# Introduction

## Purpose of this Report

This Response to Submissions Design Report has been prepared by Foster+Partners on behalf of the Pitt Street Developer North Pty Ltd to address the matters raised by government agencies, the public and community organisation groups during public exhibition of the proposed Sydney Metro Pitt Street North Over Station Development (OSD) State Significant Development (**SSD**).

## Comparison Stage 1 Envelope and SSDA Scheme

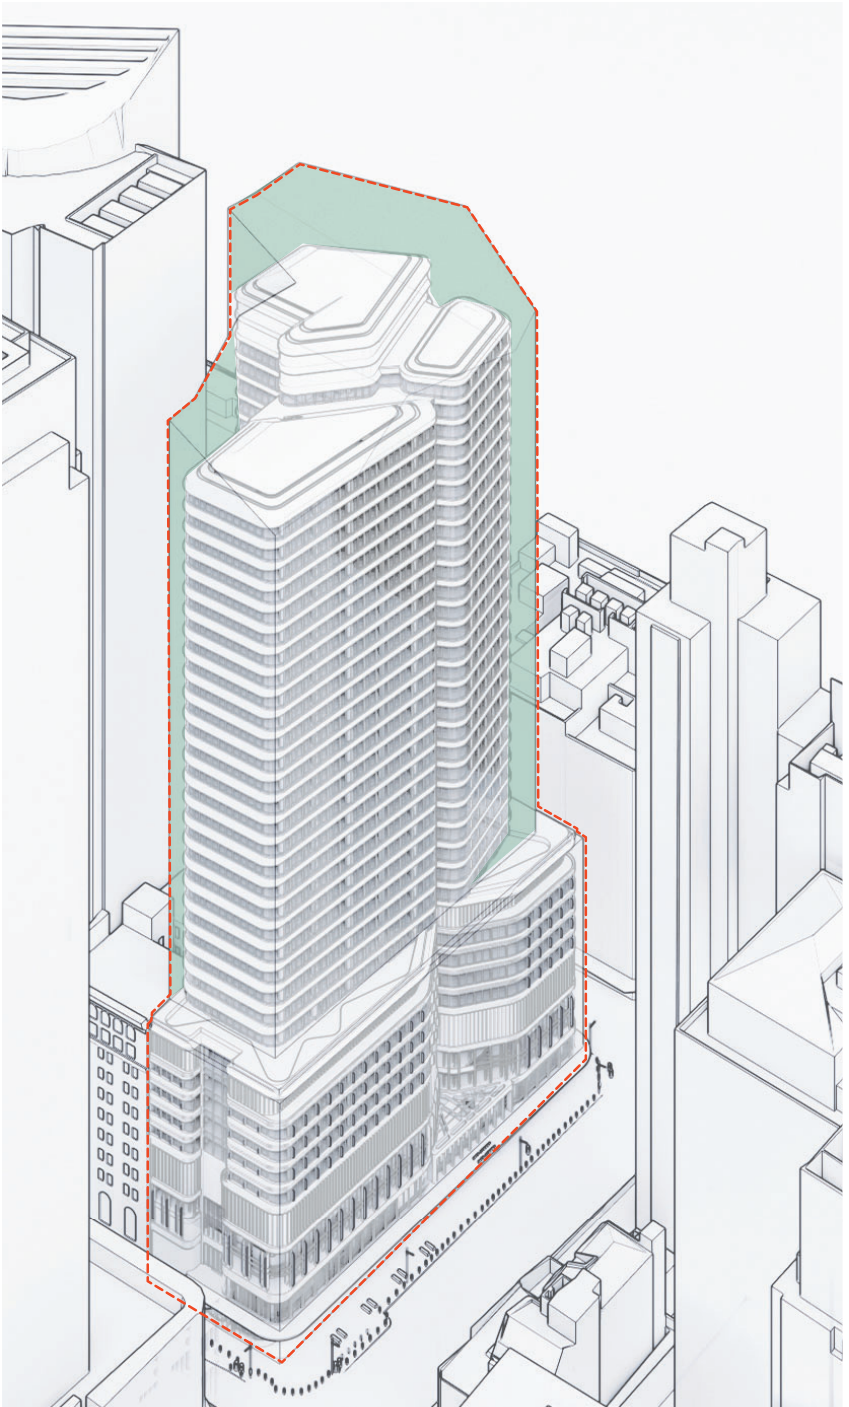
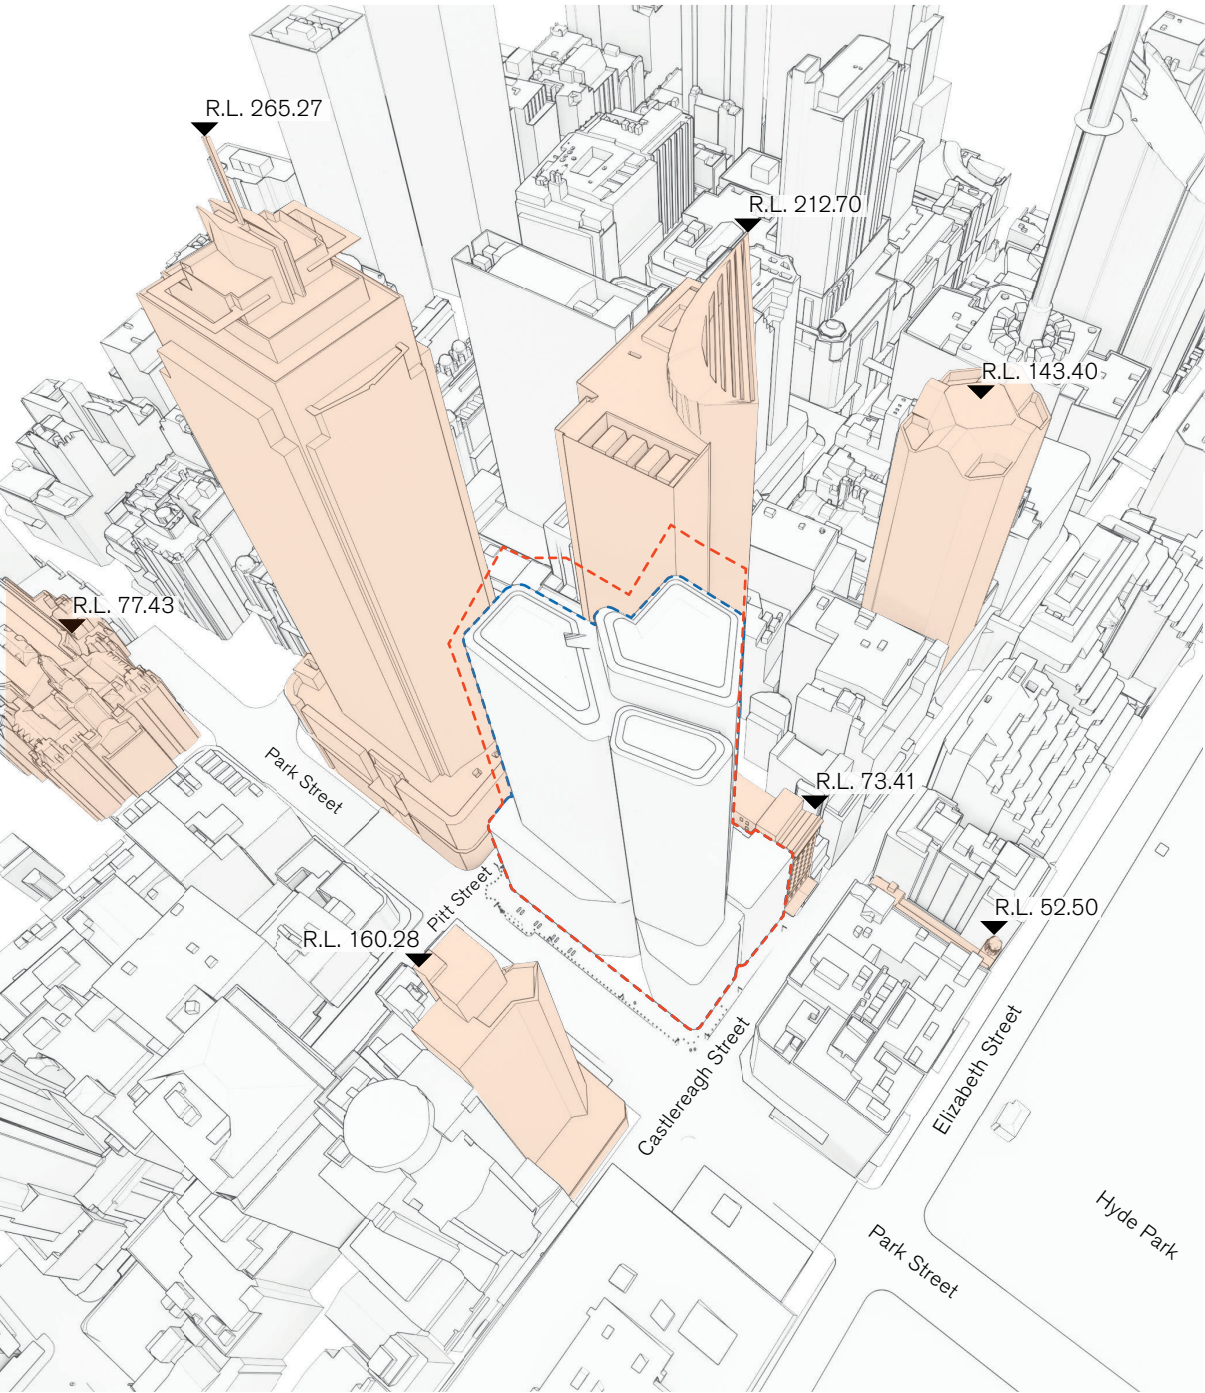
(9.c) Minimise overshadowing impacts to surrounding residences, including private residences at 27 Park Street (Park Regis).

In keeping with the design guidelines and in an attempt to allow more sunlight access to the future Town Hall Square while also allowing as much solar access to the Park Regis apartments, the South-Eastern tower volume has been angled away from the East-West Park Street axis. This deliberate move has ensured an increase in the number of Park Regis apartments achieving compliance with SEPP 65 and ADG solar access provisions, when compared with that which would result from the approved Stage 1 envelope. As a result and within the Overall envelope, only 84% has been taken up by the Commercial Development built form.

The stepped tops of the 3 distinct roof volumes, which all sit comfortably within the Solar Access plane at the top of the development, further allow additional solar access compliance under SEPP 65 and ADG to the top levels of the Park Regis tower as illustrated on the diagrams on the following pages.

Comparison SEPP65/ADG compliance Park Regis

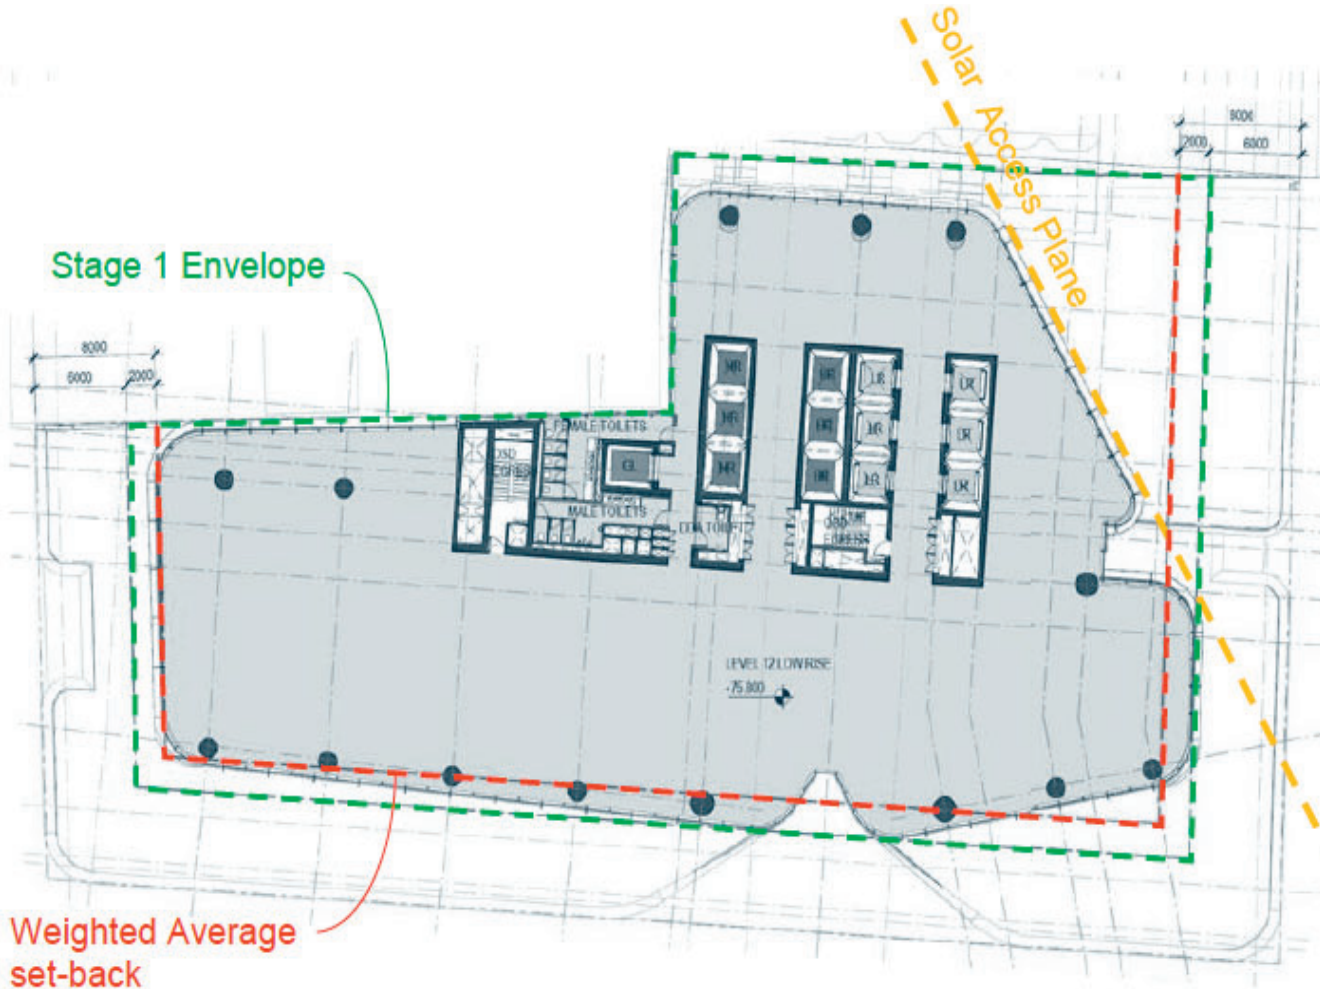
(9.c) Minimise overshadowing impacts to surrounding residences, including private residences at 27 Park Street (Park Regis).

Walsh2Architects undertook a detailed quantification of the Approved Stage 1 Envelope and the projected solar access status of individual apartments. The table on this page reports the comparison between the Stage 1 envelope and SSDA proposal in terms of SEPP65 / ADG direct sun access compliance to the Park Regis apartments.

The overshadowing impact of the SSDA proposal increases this proportion to 61/182 (33.5%) in comparison to the Approved Stage 1 envelope merely achieving 54/182 (29.7%), of an overall improvement of 13% (7 additional apartments).

Based on the above and when looking at the hours of 8AM - 4PM, solar compliance within the Park Regis residential tower increases from 129/182 (70.9%) to 154/182 (84.6%), which is an overall improvement of 19.4% (resulting in 25 additional apartments achieving SEPP 65 / ADG compliance for direct sun access) which is compliant with the objective 3B-2 of the ADG.

Option 01 Massing outline

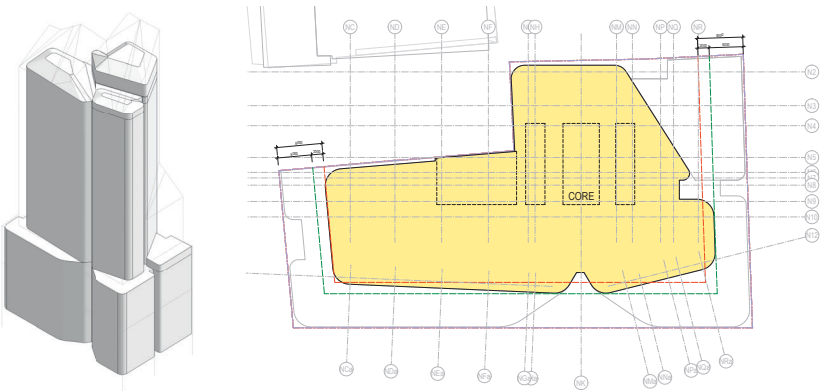
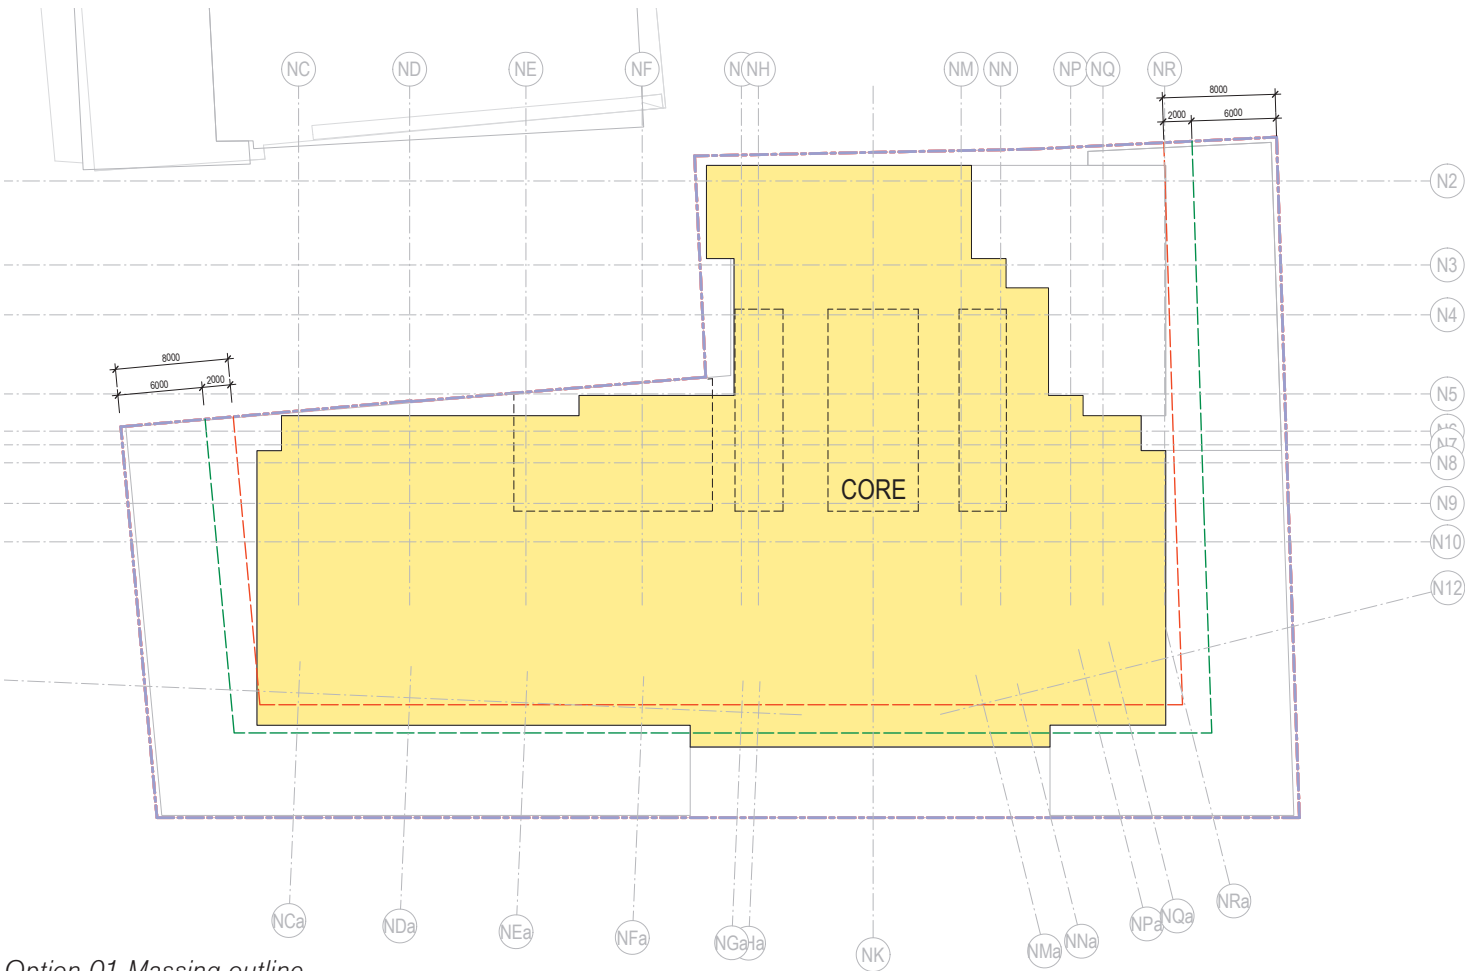
Additional massing studies to investigate ADG improvements to the Park Regis apartments.

Option 01, as illustrated on this page consists of the original massing developed in the first phases of the RFT process with Sydney Metro in 2018. The overall GFA of this scheme is on par with the total GFA figure requested for this development in the current SSDA Stage 2 application.

Upon analysis, no improvement could be measured within the solar access compliance figures (achieving 2 hours of direct sunlight on June 21, between 9Am-3PM), in actual fact 2 apartments would lose their compliance in this scheme in comparison with the currently proposed massing for the Pitt Street OSD.

Option 02 Massing outline

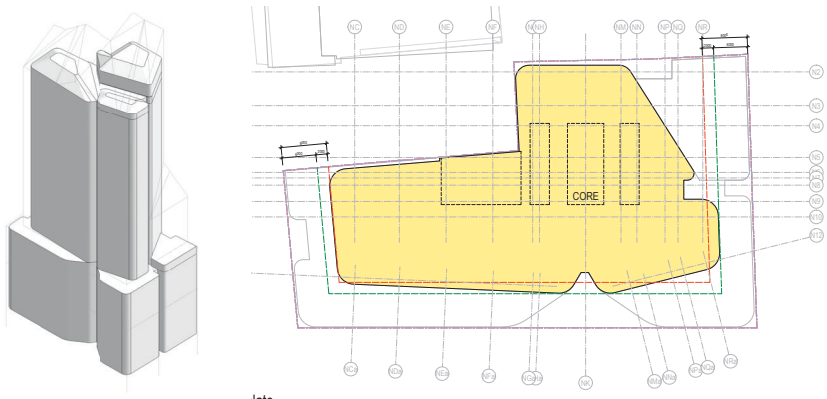
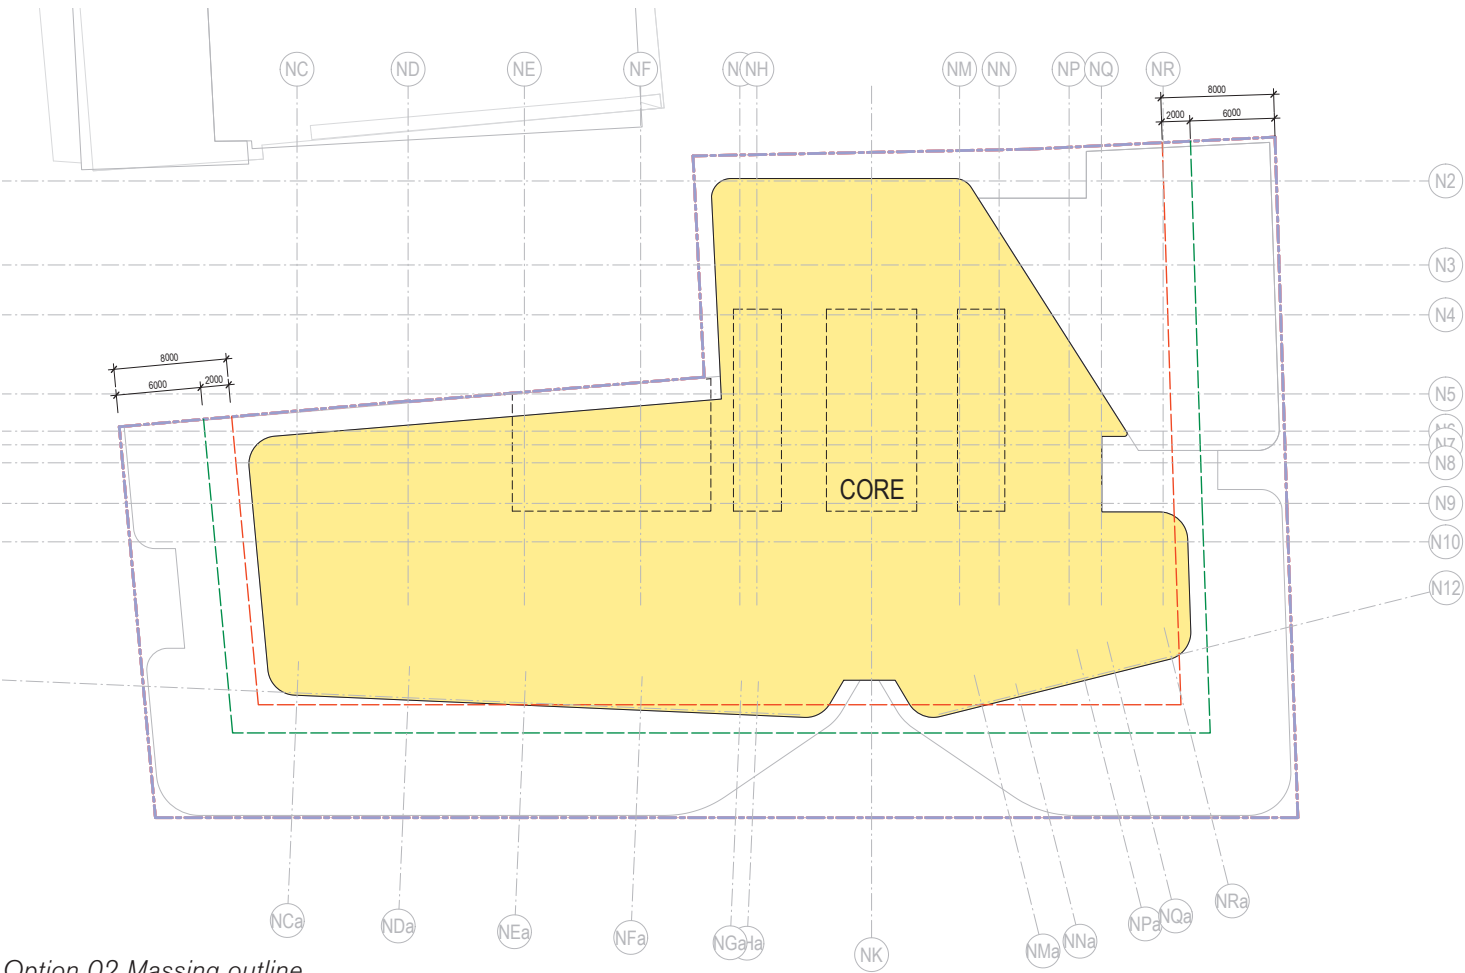
Additional massing studies to investigate ADG improvements to the Park Regis apartments.

Option 02, as illustrated on this page is similar to the current proposed SSDA massing, but has an inboard offset of 1m all around the tower outline. The overall GFA of this scheme is capped to the allowable GFA figure for the site, which is approximately 5,000 sqm less than the GFA requested in the current SSDA Stage 2 application.

Upon analysis, no improvement could be measured within the solar access compliance figures (achieving 2 hours of direct sunlight on June 21, between 9Am-3PM) in comparison with the currently proposed massing for the Pitt Street OSD.

Furthermore this change would also result in a reduced expression / articulation of the 3 distinct tower volumes when viewed from Hyde Park, and thus negatively impacting the carefully considered moves to break the massing alignment between ANZ and the new 201 Elizabeth St Stage 1 Envelope (Design Guideline 4/5/10/11)

Option 03 Massing outline

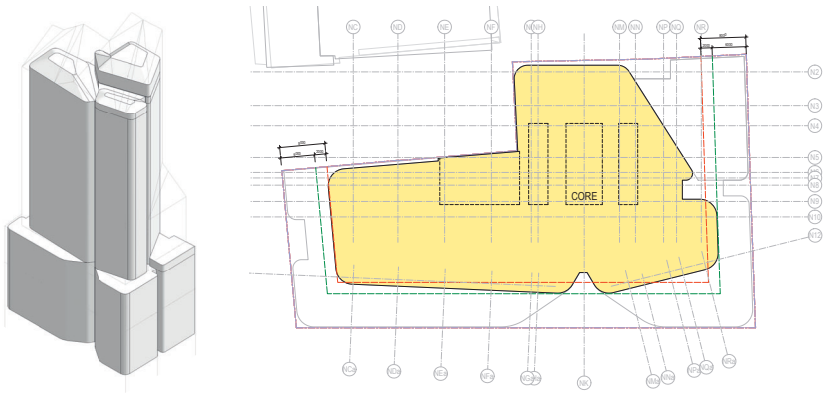
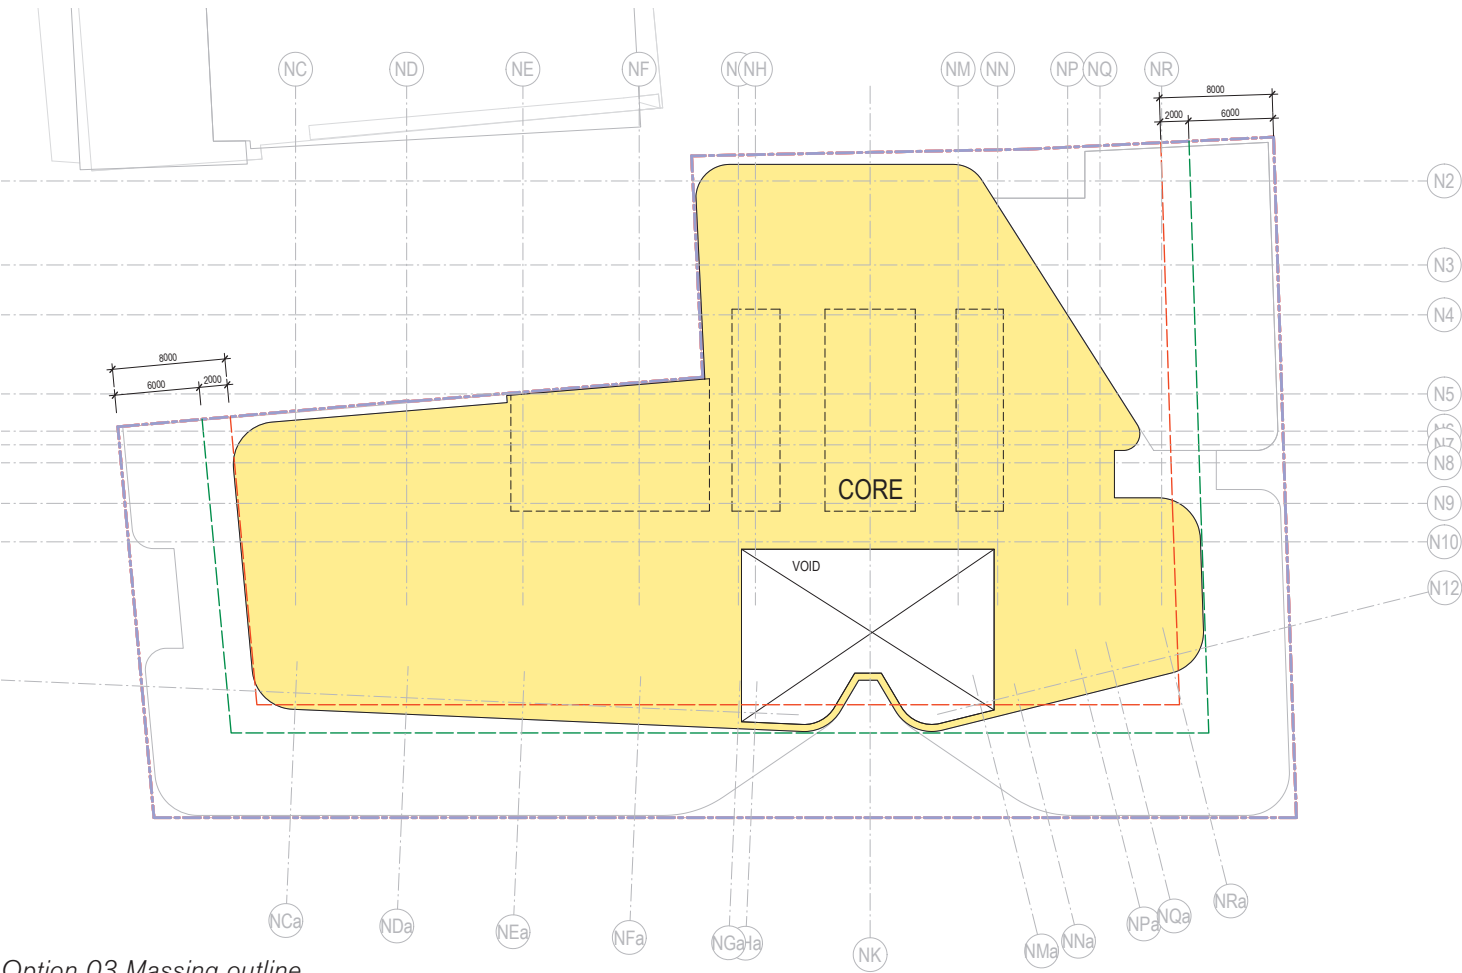
### Additional massing studies to investigate ADG improvements to the Park Regis apartments.

Option 03, as illustrated on this page is identical to the current proposed SSDA massing, but through the introduction of building voids has a total GFA capped to the allowable GFA figure for the site, which is approximately 5,000 sqm less than the GFA requested in the current SSDA Stage 2 application.

Upon analysis, no improvement could be measured within the solar access compliance figures (achieving 2 hours of direct sunlight on June 21, between 9Am-3PM), in comparison with the currently proposed massing for the Pitt Street OSD.
